RECEIPT DATE: 5-7-14 **ONSITE SEWAGE DISPOSAL SYSTEM** P SH6351

PROPERTY ADDRESS: 12319 Pleasant View Drive

SUBDIVISION: Fulton Manor II LOT: 7 TAX ID: _____

| SCALE 1" = 50' | DATE 05/07/14 | ROBERT H. VOGEL ENGINEERING, INC. ENGINEERS - SURVEYORS - PLANNERS 8407 MAIN STREET ELLCOTT CITY, MARYLAND 21043 TEL: 410-461-7666 FAX: 410-461-8961 | WALL CHECK DRAWING 12319 PLEASANT VIEW DRIVE LOT 7 FULTON MANOR II PLAT NO. 22479 FIFTH ELECTION DISTRICT HOWARD COUNTY, MARYLAND |

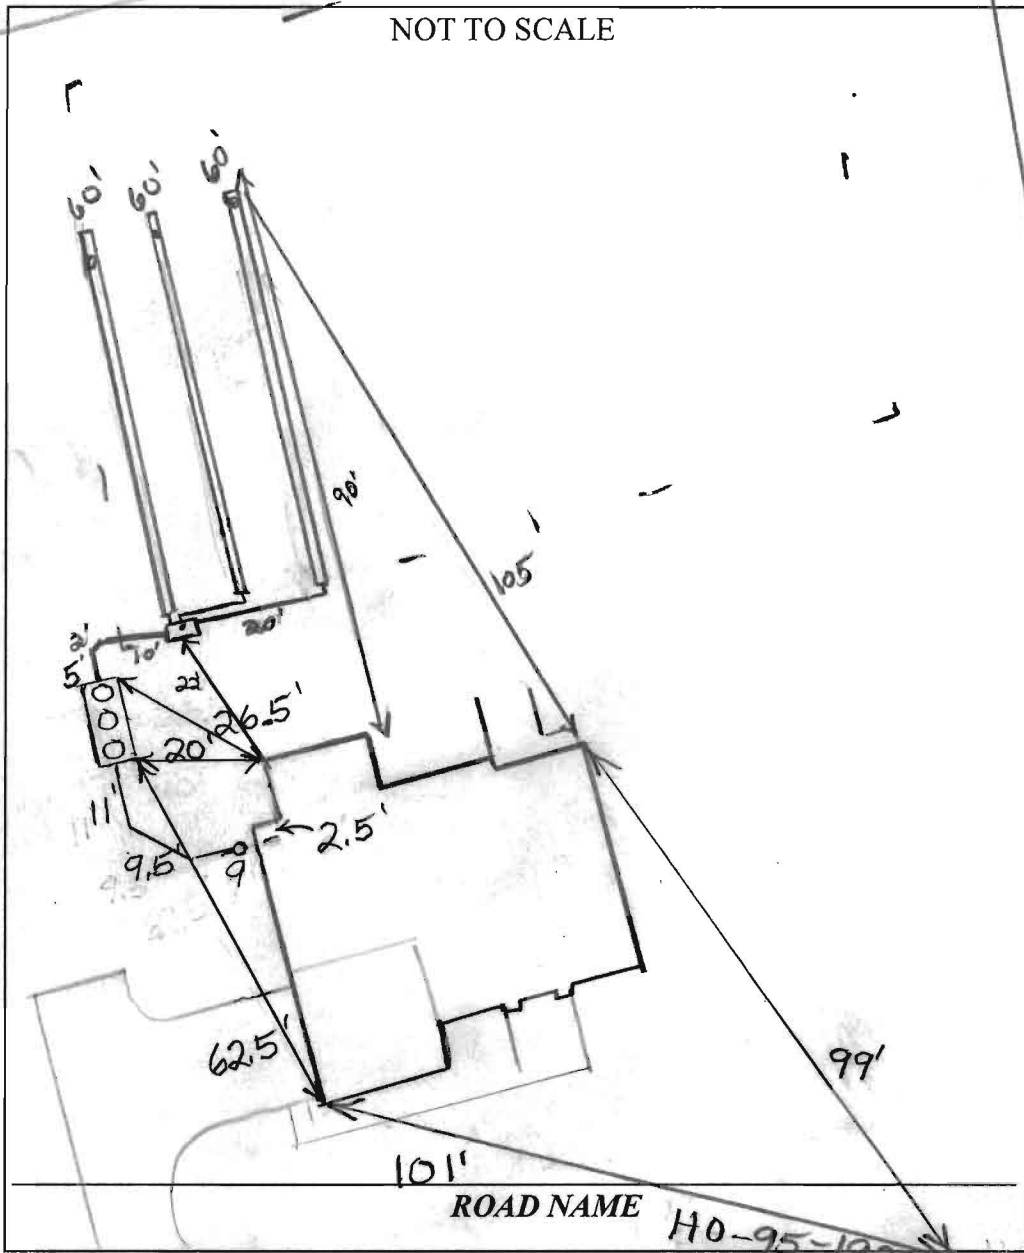
6/25/14 could not find permits. BAT not staked, looked to be previous structure existed in entire area of SPA. Contours off by 8" Laid out trenches per original perc cut contours and BAT site plan. Install tank as shown. Call for inspection (RW)

7/2/2014 Need house connection. Tank set. (RB)
 7/7/14 D box set, lower trench installed. Working on middle trench. Checking grades and cuts on trenches looks good. (RW)
 7/8/14 D box leveled. No one on-site. System complete. Last trench must remain unconnected (not back filled) to inspect. Red pipes in dirt to secure them safely. OK to pour. (RW) 7/9/14 BAT startup received.
